CALL NO. 100
CONTRACT ID NO. 241306
ADDENDUM # 1

Subject: Breathitt County, NHPP 0151 (090)
Letting March 21, 2024

- (1) Added - Traffic Management Plan - Pages 583A-583L of 649
- (2) Revised - Plan Sheets U-039, U-041, U-042, U-044, U-045, U-047

Sheet No.	U-039
City of Jackson - Utility Relocation	BREATHITT COUNTY, KY - KY15, ITEM NO. 376.00
Date	2023-08-17
Drawn By	JCM
Scale	AS SHOWN
Job No.	933.40

CITY OF JACKSON
UTILITY RELOCATION
BREATHITT COUNTY, KY - KY15
ITEM NO. 10-376.00
WENDY'S LIFT STATION DETAILS

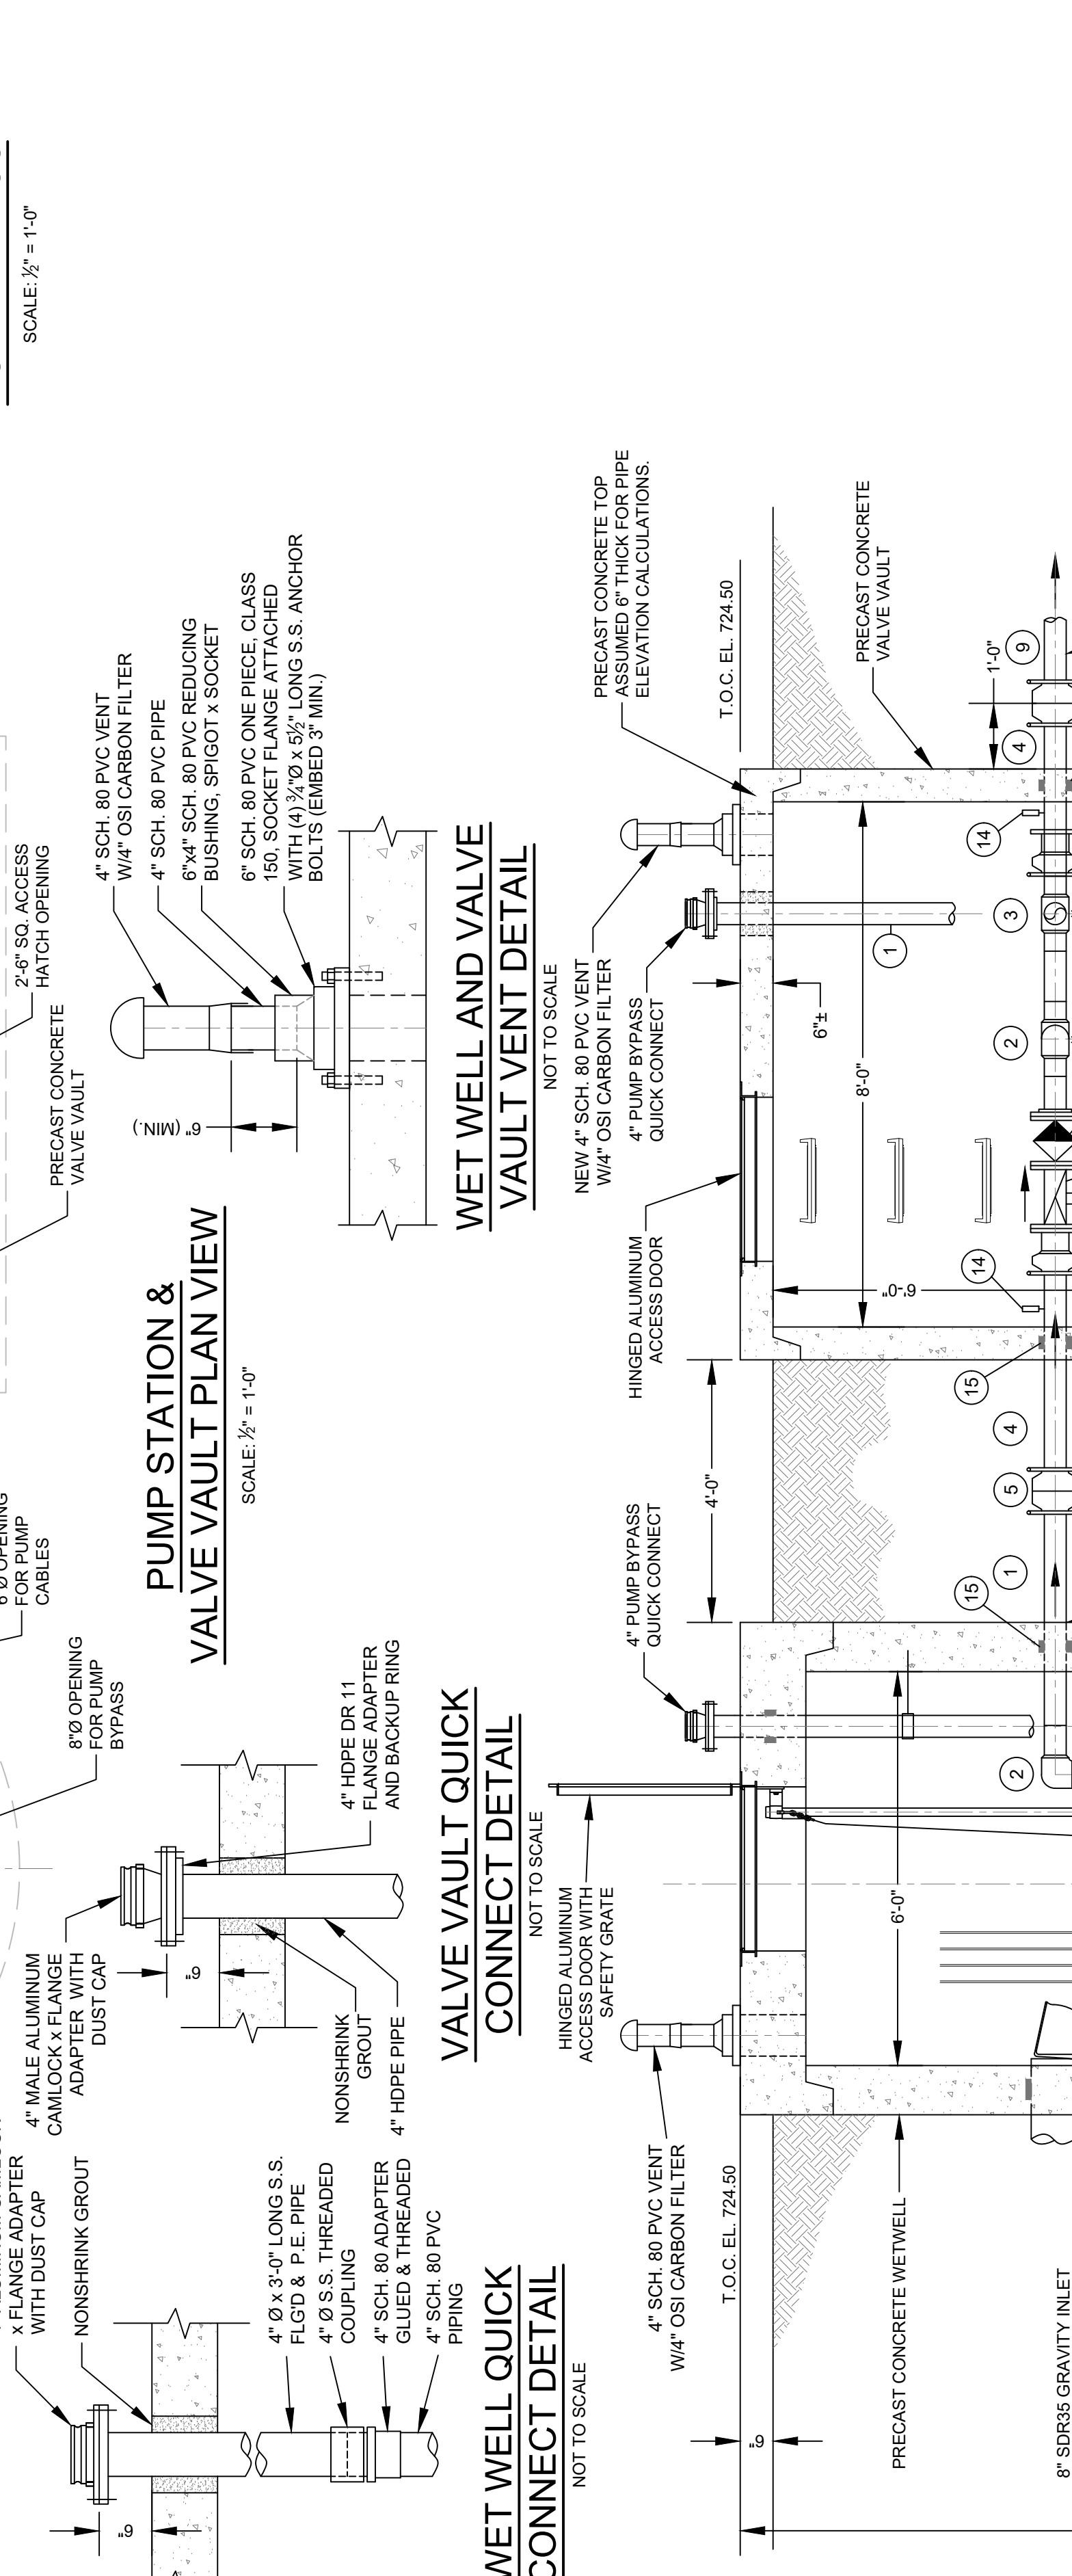
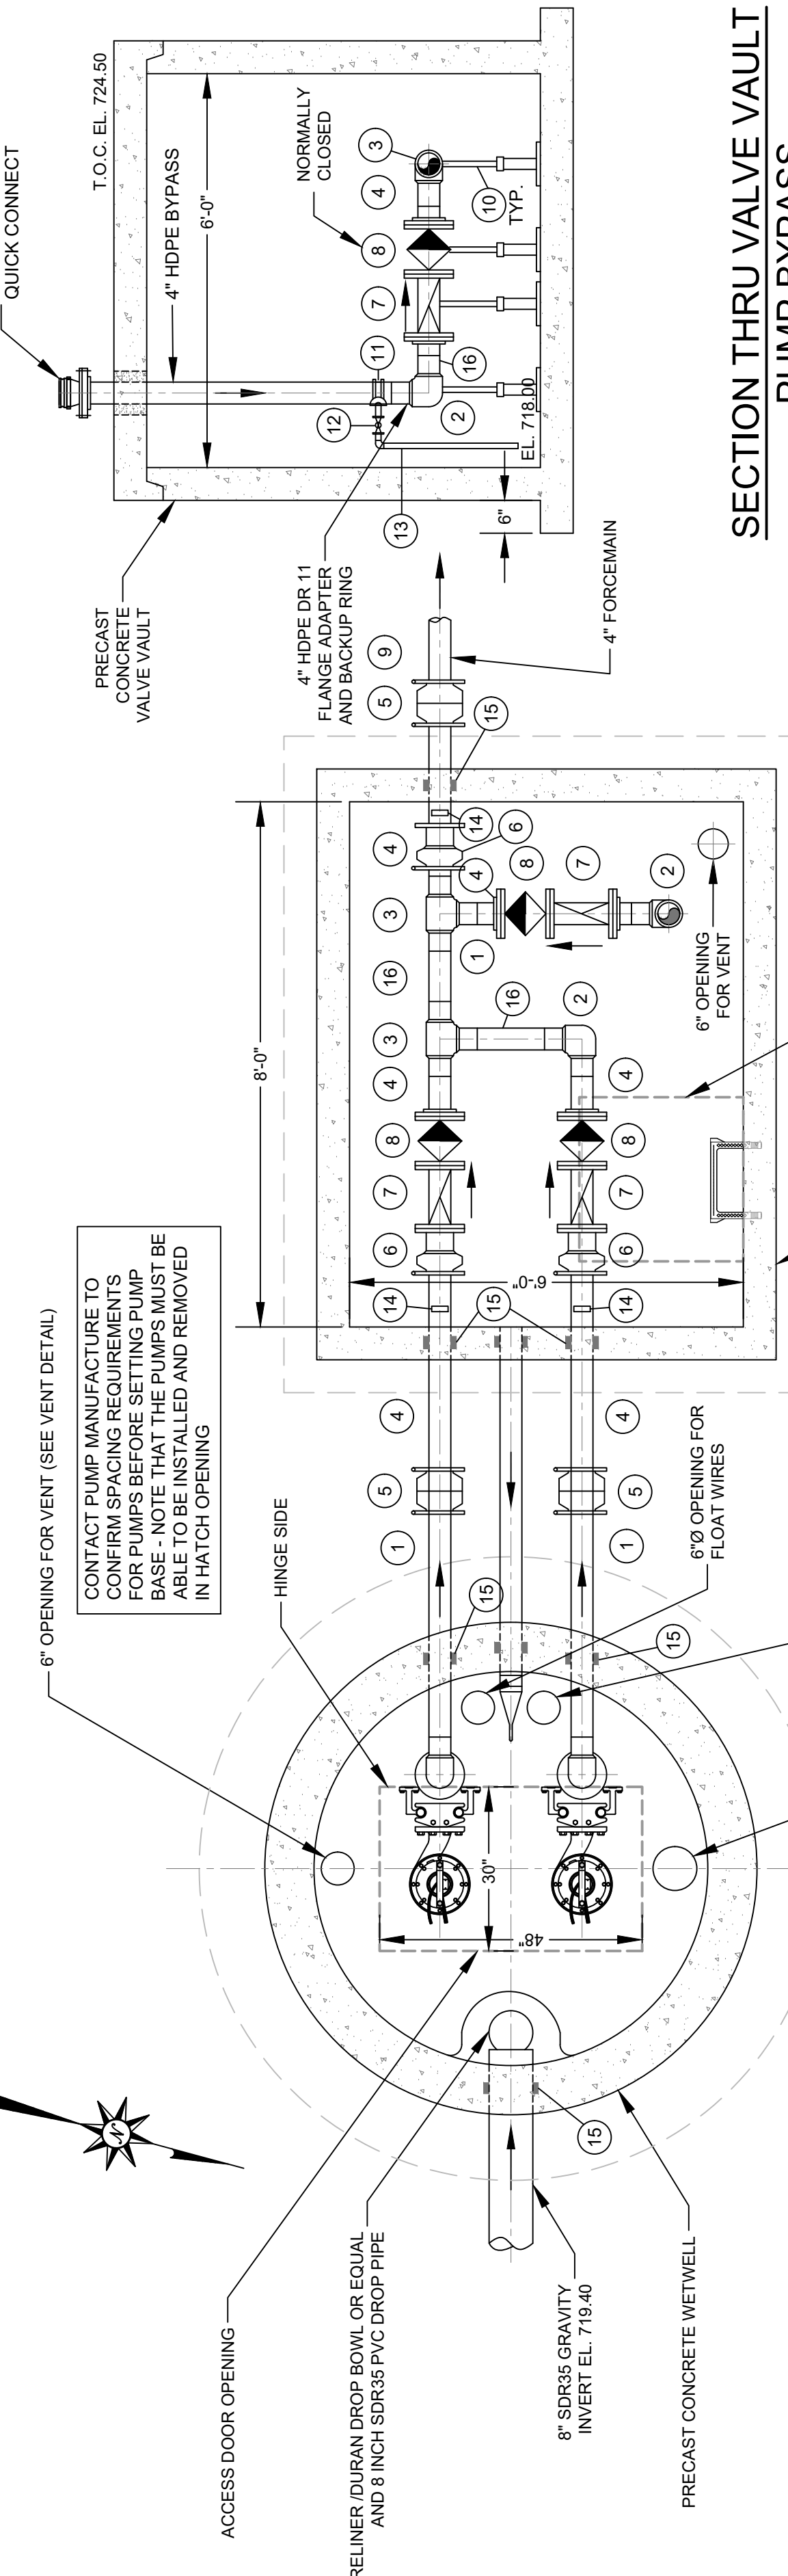
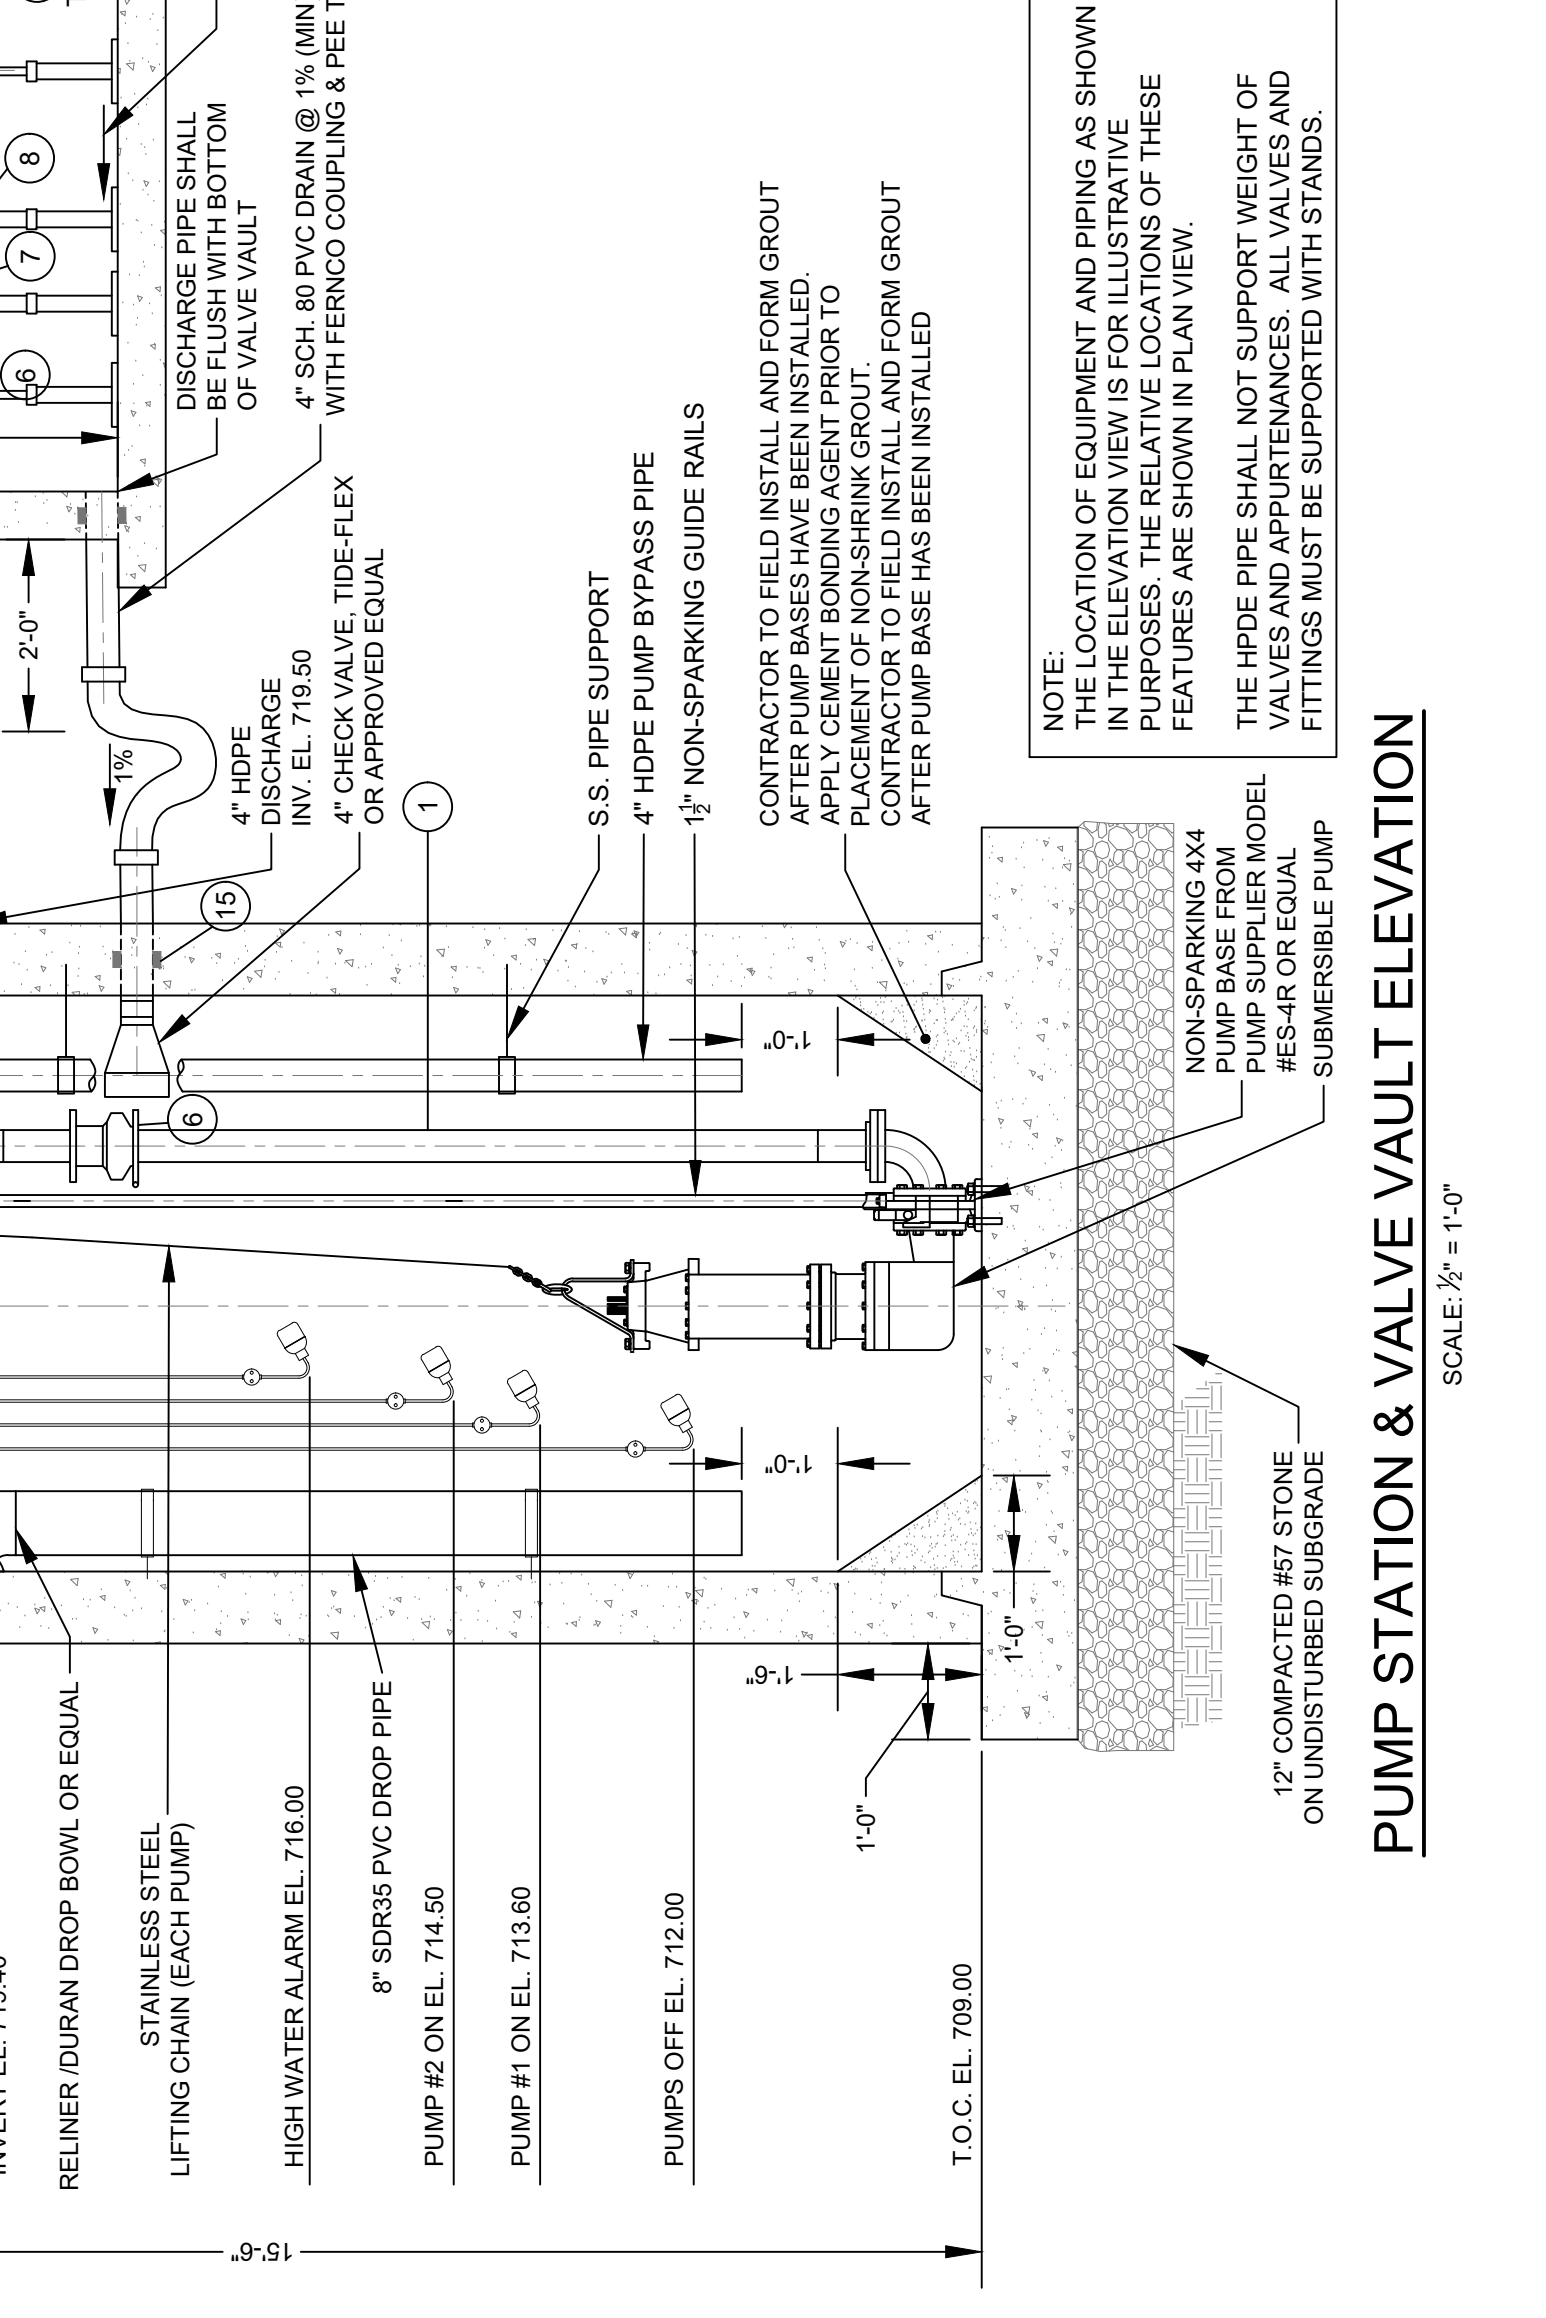
2023-11-17 RELOCATED WET WELL DRAIN TO WET WELL (JCM)
 2024-02-20 ADD 1 CHANGE TO DUCTILE IRON PIPING IN LIFT STATION.
